STATE OF NORTH CAROLINA
DEPARTMENT OF TRANSPORTATION

May 1, 2020

Subject: Revised Modification Request for the Section 404 Individual Permit and Section 401 Water Quality Certification for the proposed Havelock Bypass in Craven County. TIP No. R-1015. Debit \$ 570 from WBS 34360.1.2

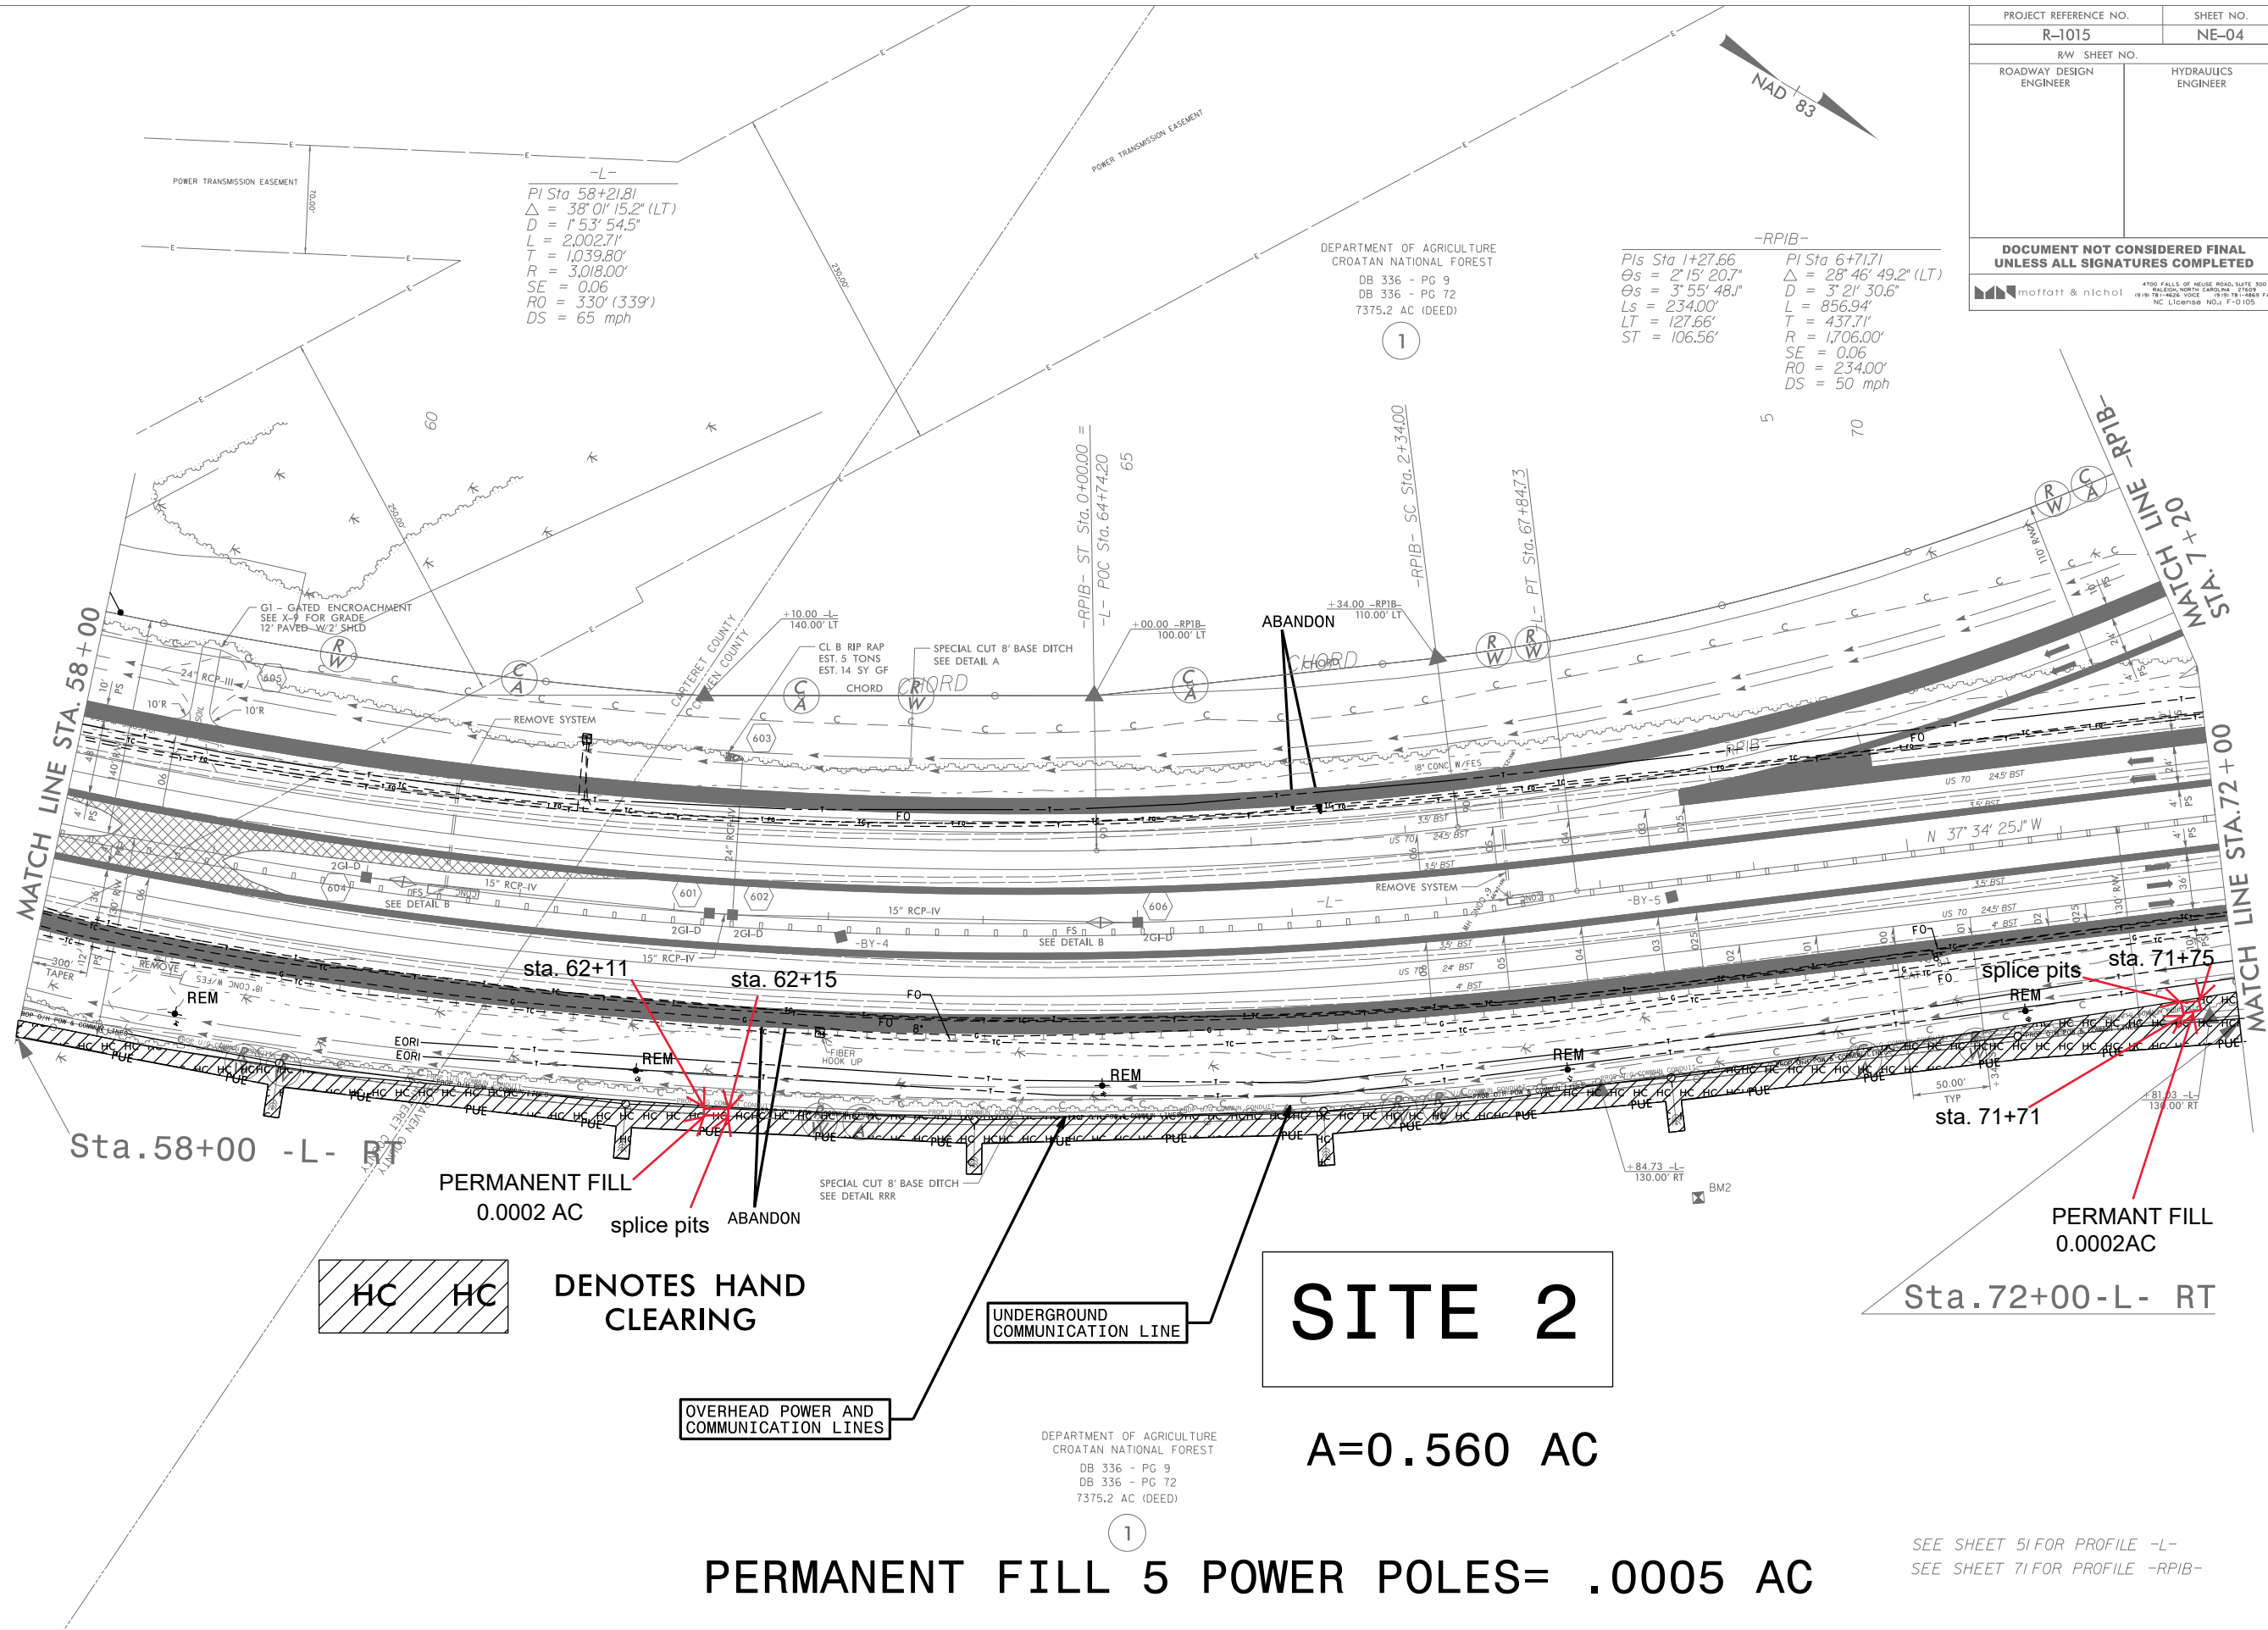
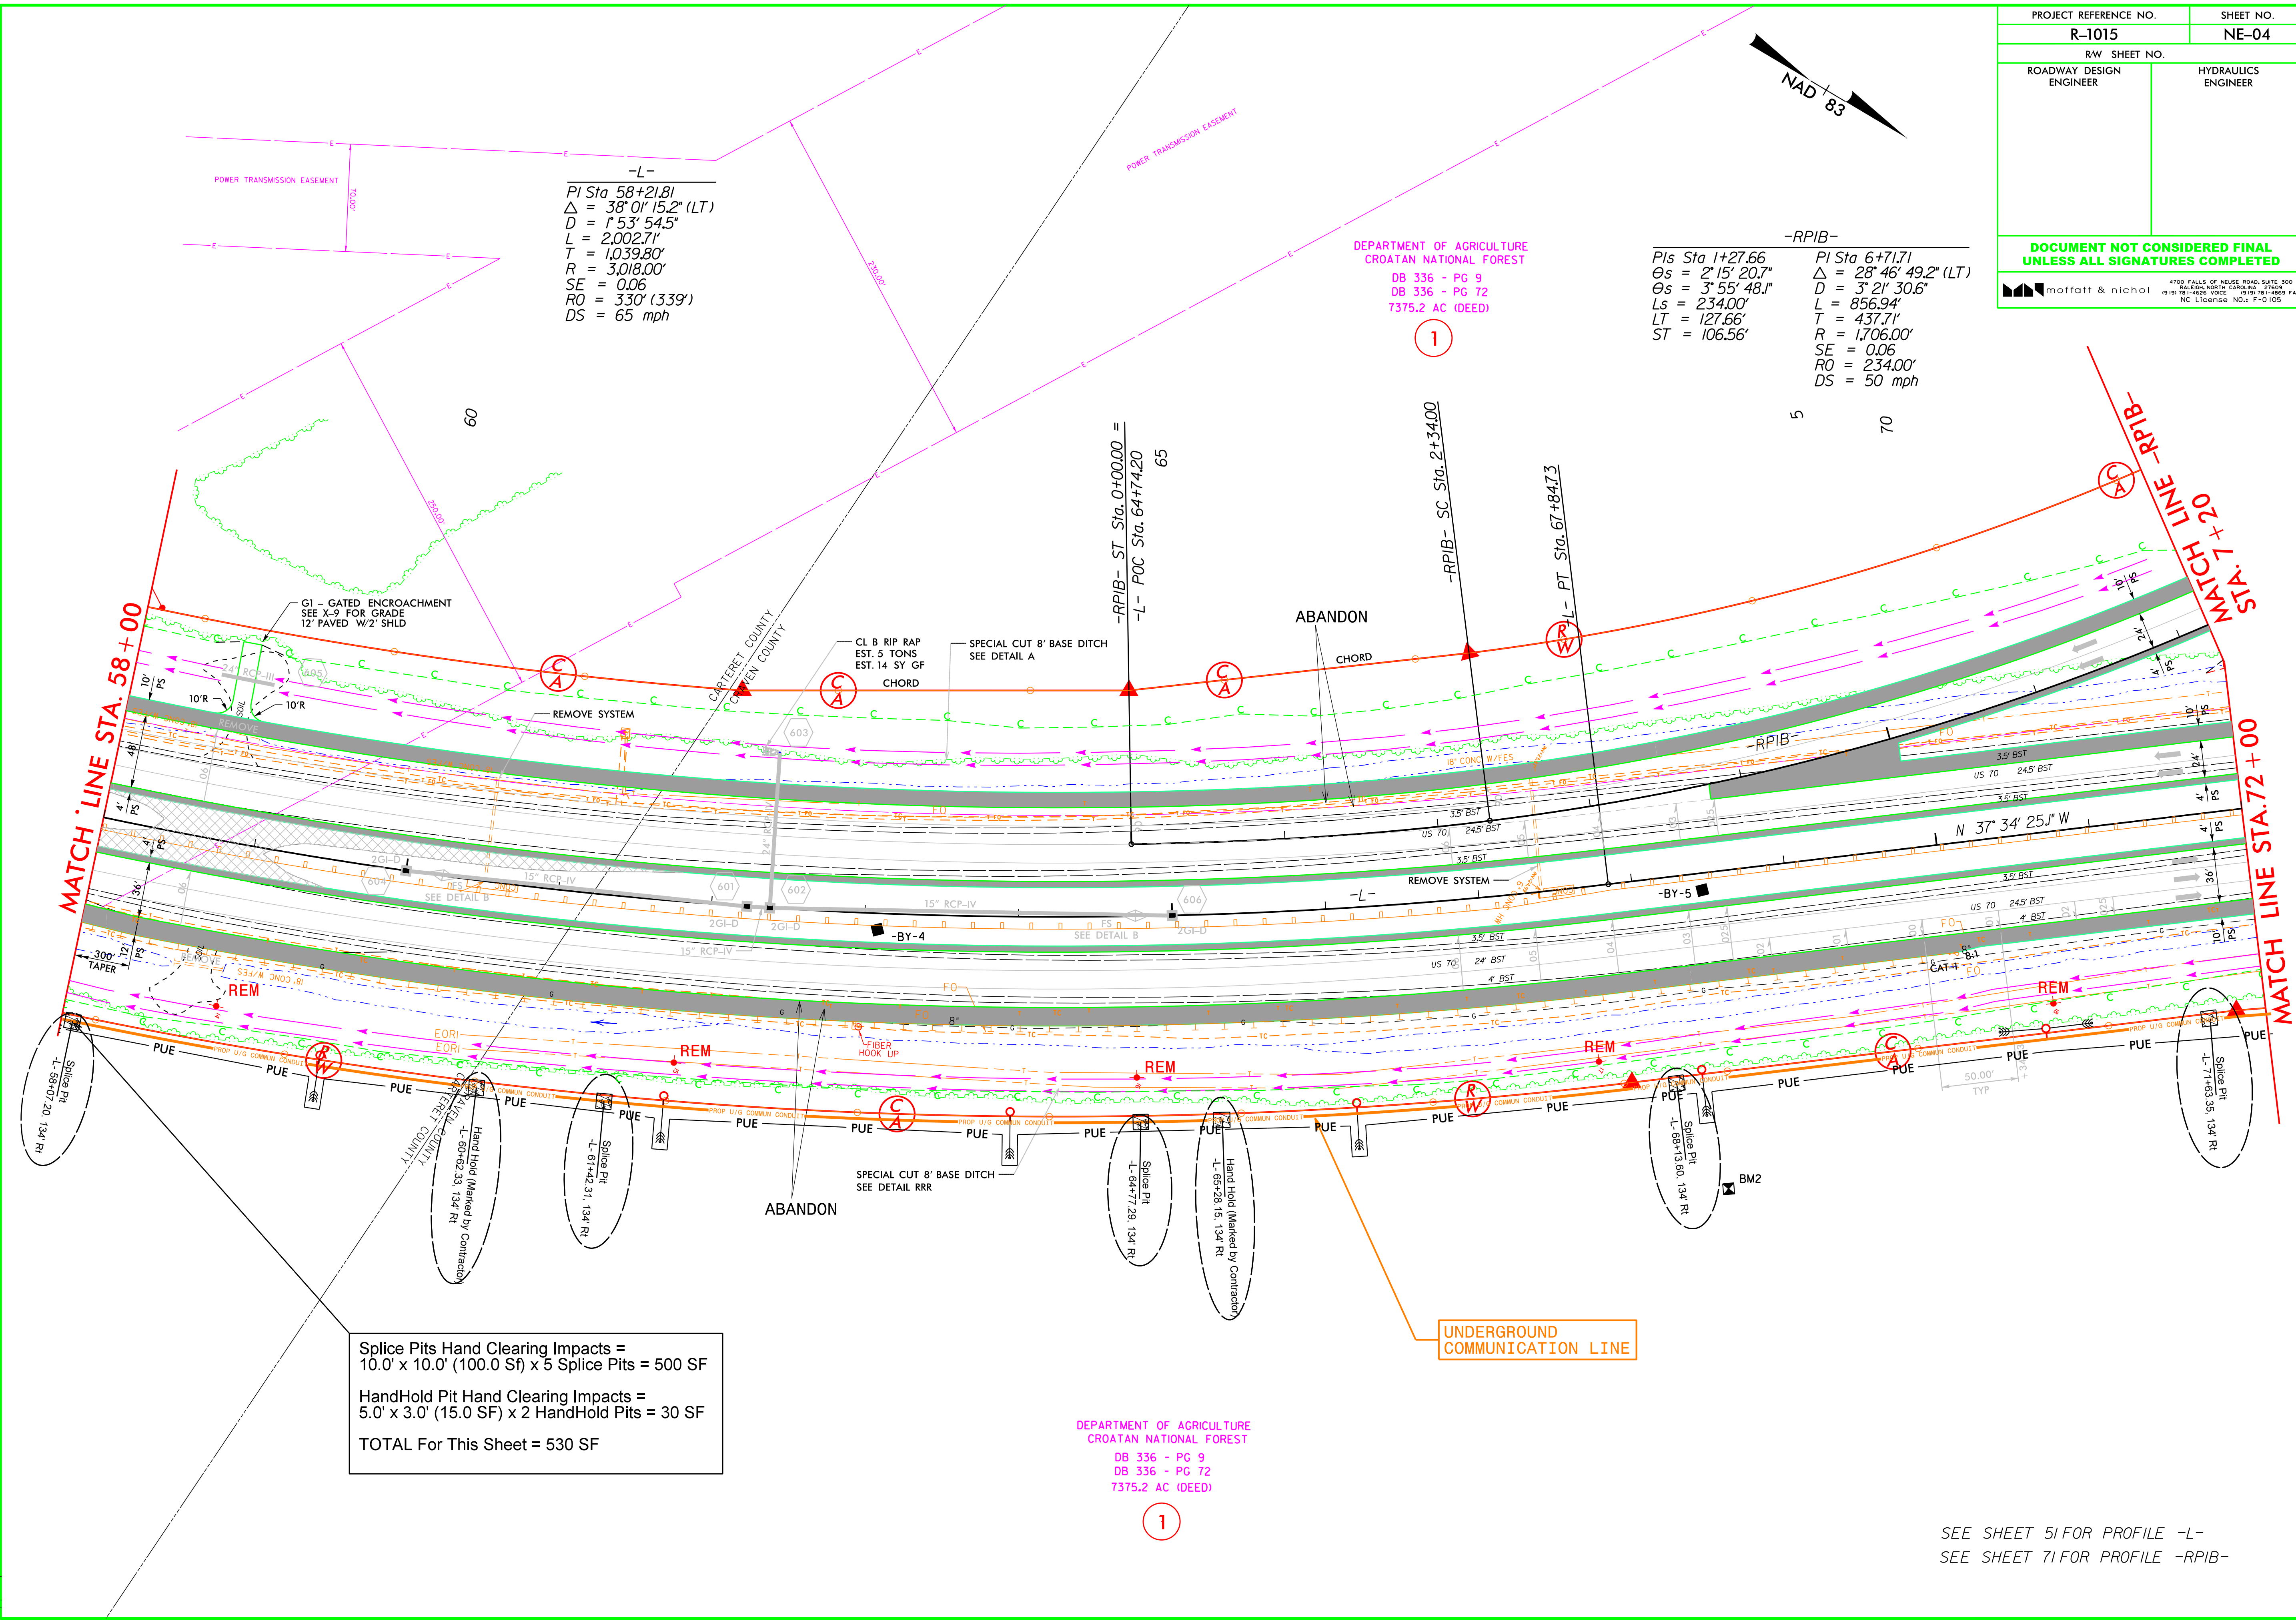
- Total permanent impact from hydraulics and roadway changes increased by 0.03 acre.
- Additional sheets have been prepared for the underground utility which requires additional impacts in wetland Sites 1, 2 and 3. The permit drawings showed underground utilities through these sections, but with no splice pits or hand holes, which are required. These supplemental drawings were revised by Division 2 to show the permanent hand holes and temporary splice pits with the total impacts required. Impacts shown on the supplemental permit drawings are as follows:

- = NE-03 (Site 1), 409 s.f. for splice pits and 15 s.f. for hand holes
 - = NE-04 (Site 2), 518 s.f. for splice pits and 30 s.f. for hand holes
 - = NE-05 (Site 3), 600 s.f. for splice pits and 30 s.f. for hand holes

- = Additional total impacts needed = 1,602 s.f. (0.037 acre) of excavation and handclearing for bore splice pits and hand holes. Additional coordination with Division 2 staff indicated this work should be counted as permanent impacts. Five utility impact sheets and the utility impact summary sheet have been updated. These three additions can be seen listed at the bottom of the site list as excavation impacts.
